SUBJECT: SHEARON HARRIS NUCLEAR POWER PLANT, UNIT 1 – STAFF
ASSESSMENT OF RESPONSE TO 10 CFR 50.54(f) INFORMATION
REQUEST FLOOD CAUSING MECHANISM REEVALUATION (TAC NO.
MF1103)

STAFF ASSESSMENT BY THE OFFICE OF NUCLEAR REACTOR REGULATION
RELATED TO FLOODING HAZARD REEVALUATION REPORT
NEAR-TERM TASK FORCE RECOMMENDATION 2.1
SHEARON HARRIS NUCLEAR POWER PLANT, UNIT NO. 1
DOCKET NO. 50-400

Figure 3.1-1. Locations of Main and Auxiliary Dams and Reservoirs in the Buckhorn Creek Drainage, and Sub-basins Used for the Flooding Analyses from Stream and Rivers.

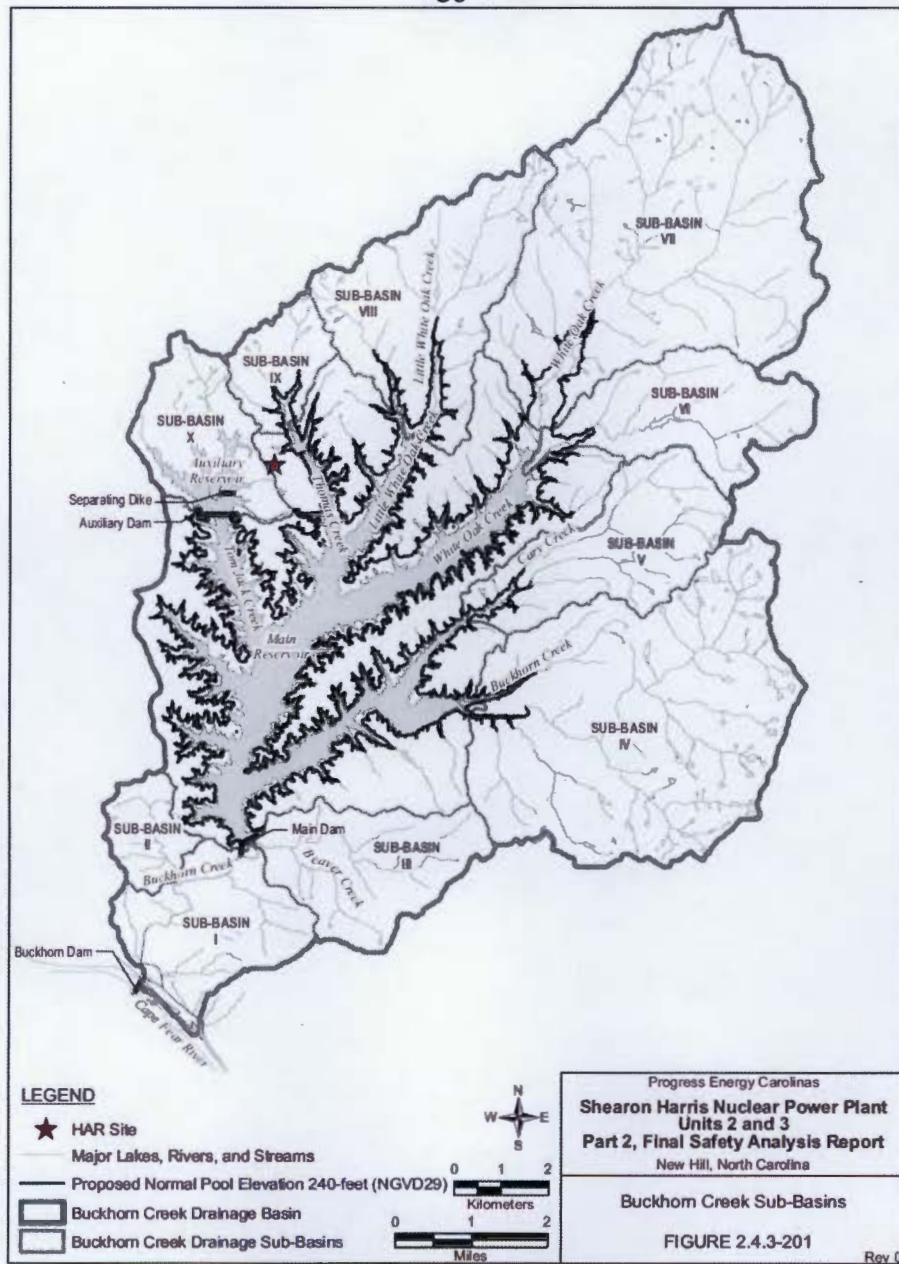
The FHRR identified the Buckhorn Creek watershed, with an area of 70.3 mi² (182.1 km²), as the primary drainage upstream of the Main Dam, as shown on Figure 3.1-1. Figure 3.1-1 also shows the Auxiliary Dam, which discharges to the Main Reservoir upstream of the Main Dam, and has a watershed of 3 mi² (8 km²).

Figure 3.2-1. Locations of Buildings, Subbasins, and Cross Sections in the HNP Unit 1 Site Hydraulic Model

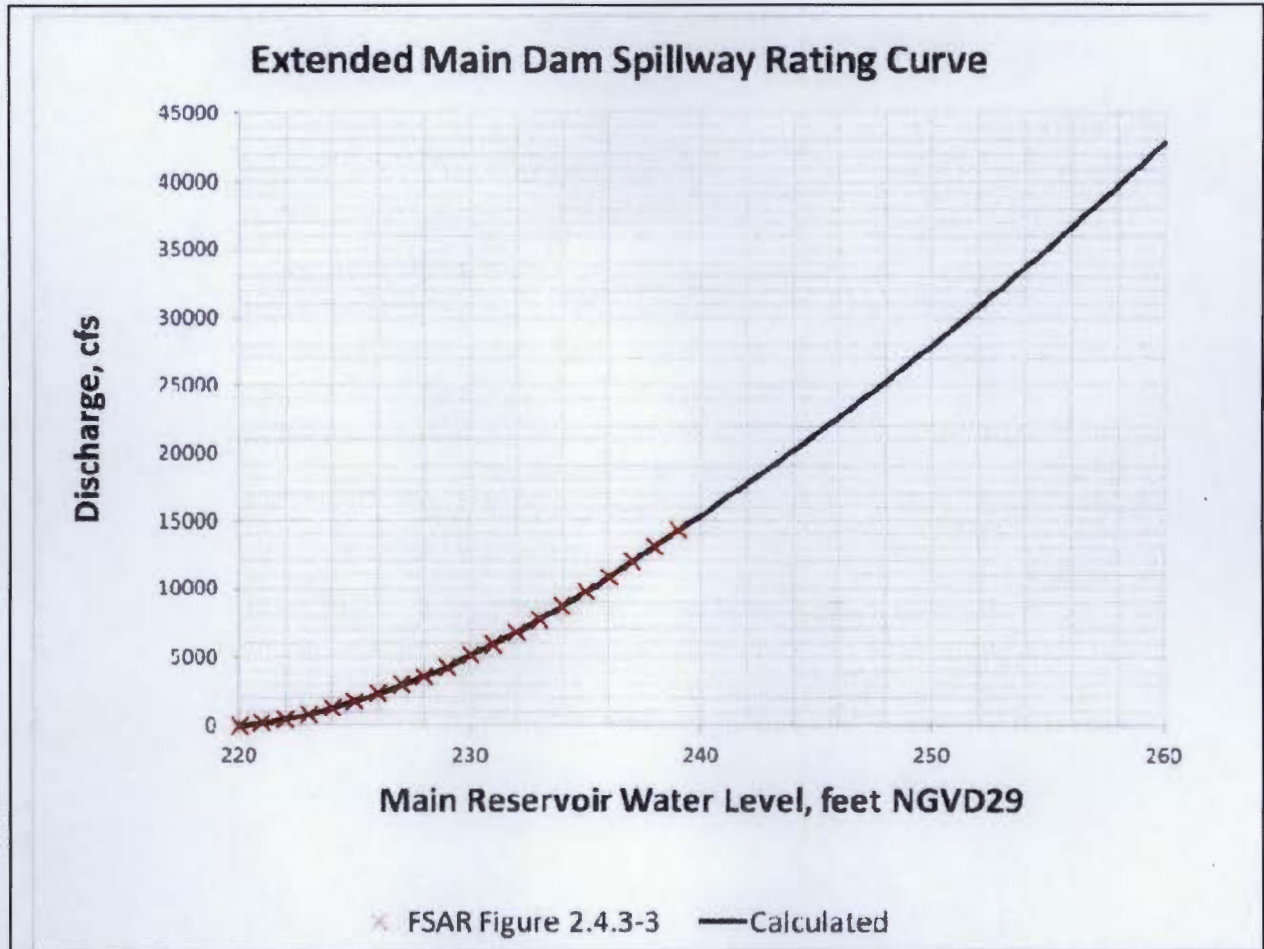
The FHRR described four areas (i.e., subbasins 5, 6, 8, and 16; Figure 3.2-1) with sumps and containment areas that would retain all runoff and excluded the runoff contribution from these subbasins in its LIP flood analysis. The four areas described by the licensee (Duke, 2013 and Duke, 2014b) are expected to retain the building runoff from the LIP event in sumps, or in containment areas located between retaining walls.

For the storage areas with sumps (subbasins 5, 6, and 16; Figure 3.2-1), the licensee stated that when the storage volume of each sump is filled to an elevation of 261 ft (79.6 m), any additional runoff will spill onto the site. For the containment volume in the Tank Building (subbasin 8; Figure 3.2-1), which is between the Tank Building and the walls that enclose the building area, the licensee states that the storage volume will contain all of the LIP runoff from the building (Duke, 2014b). The top of the wall is 286 ft (87.2 m) and the invert between the walls is 261 ft (79.6 m) (Duke, 2014b). According to the licensee (Duke, 2014b), the LIP will fill the Tank Building storage to an elevation of 276.1 ft (84.16 m), which the staff estimated is only 60 percent of the total storage capacity. The staff considered the possibility that storm events with longer durations and hence, larger accumulated depths, could also occur, which is the case for the basin-wide PMP examined in Section 3.3.

The FHRR stated that a HEC-RAS hydraulic model of the site was developed for the LIP analysis and was applied to route the runoff from the subbasins along the estimated flow paths. As discussed below, the staff reviewed the cross-section information contained in the model's input file. The locations of the model's cross-sections are shown in Figure 3.2-1.
